<b>DOCKETED</b>	
<b>Docket Number:</b>	25-OPT-02
<b>Project Title:</b>	Prairie Song Reliability Project
<b>TN #:</b>	268334
<b>Document Title:</b>	Jacqueline Ayer Comments - Supplemental comment letter from Save Our Rural Town
<b>Description:</b>	N/A
<b>Filer:</b>	System
<b>Organization:</b>	Jacqueline Ayer
<b>Submitter Role:</b>	Public
<b>Submission Date:</b>	1/27/2026 4:52:56 PM
<b>Docketed Date:</b>	1/27/2026

## **Supplemental comment letter from Save Our Rural Town**

Subject: Supplemental Comments by Save Our Rural Town (SORT).

Reference: AB-205 Application Submitted for a Proposed Battery Energy Storage Project in Acton, CA.  
Docket Number 25-OPT-02.  
Email correspondence between Applicant and the Los Angeles County Fire Department posted to the Docket on January 26, 2026.

Figure 1. Proximity of the BESS Project to the Adjacent Major Highway.

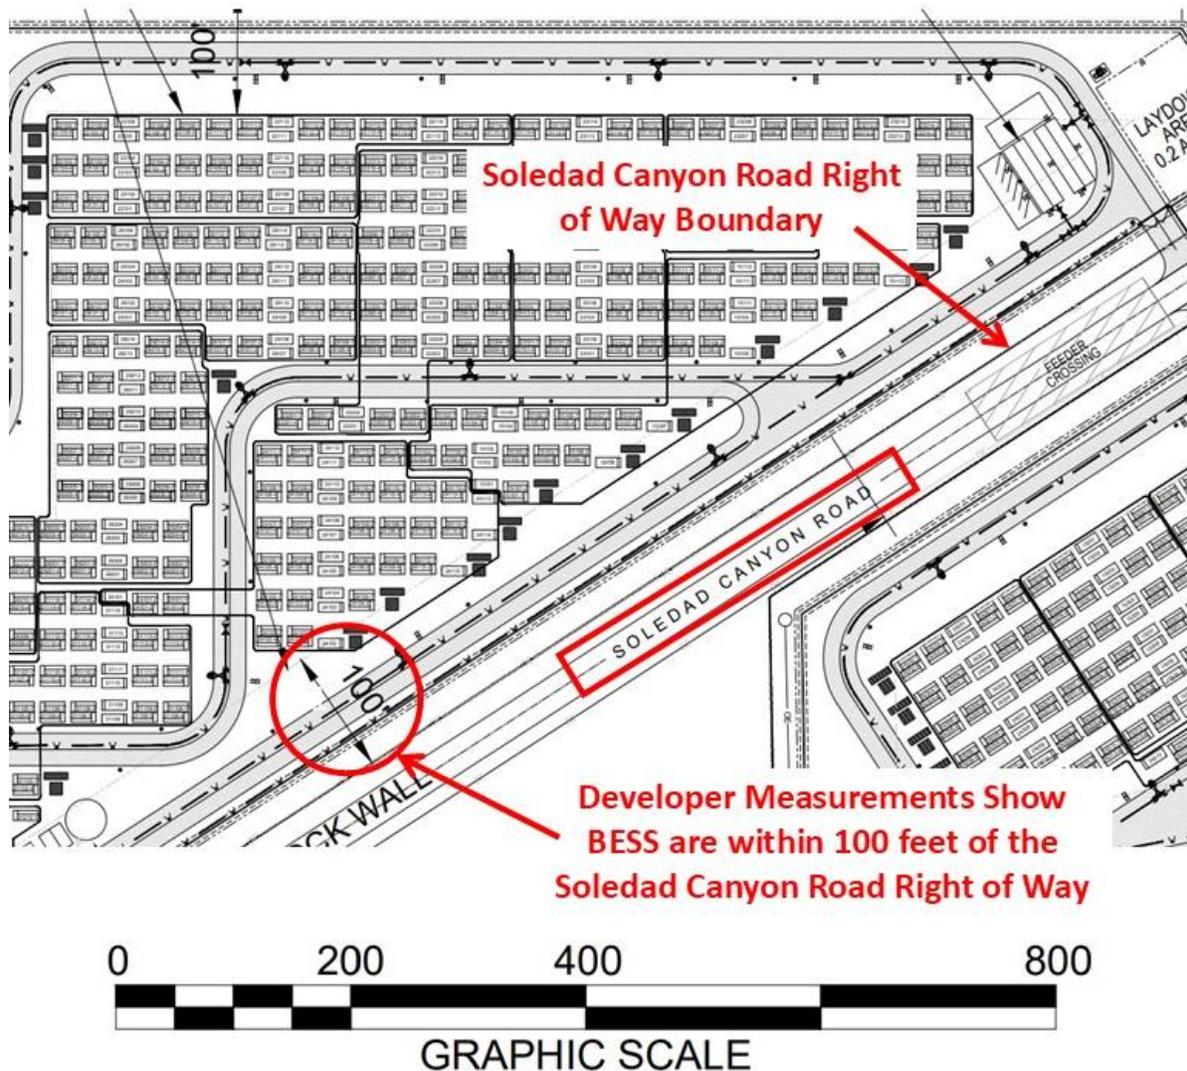
Figure 1 is an excerpt from the Developer’s recently revised site plan<sup>1</sup> and it shows that the project is *immediately adjacent to a major highway* (Soledad Canyon Road) which serves as a critical commuter corridor and is mapped on the County Highway Plan<sup>2</sup>. In fact, the Developer’s own measurements show that the BESS units themselves are located within 100 feet of the right of way of this major commuter highway, and the perimeter wall appears to be approximately 20 feet from the right of way.

Figure 3. Proximity of the BESS Project to the Adjacent Railway.

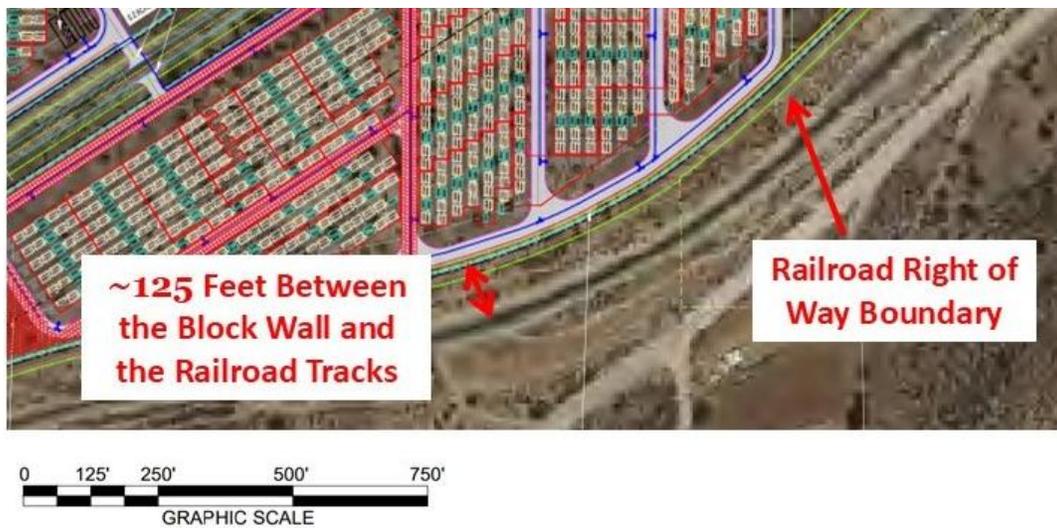
Finally, and as shown in Figure 3, the Developer’s most recent site plan<sup>4</sup> indicates that the project boundary coincides with the right of way boundary of the adjacent railway, and that the project’s block wall is actually within 125 feet of the railway tracks.
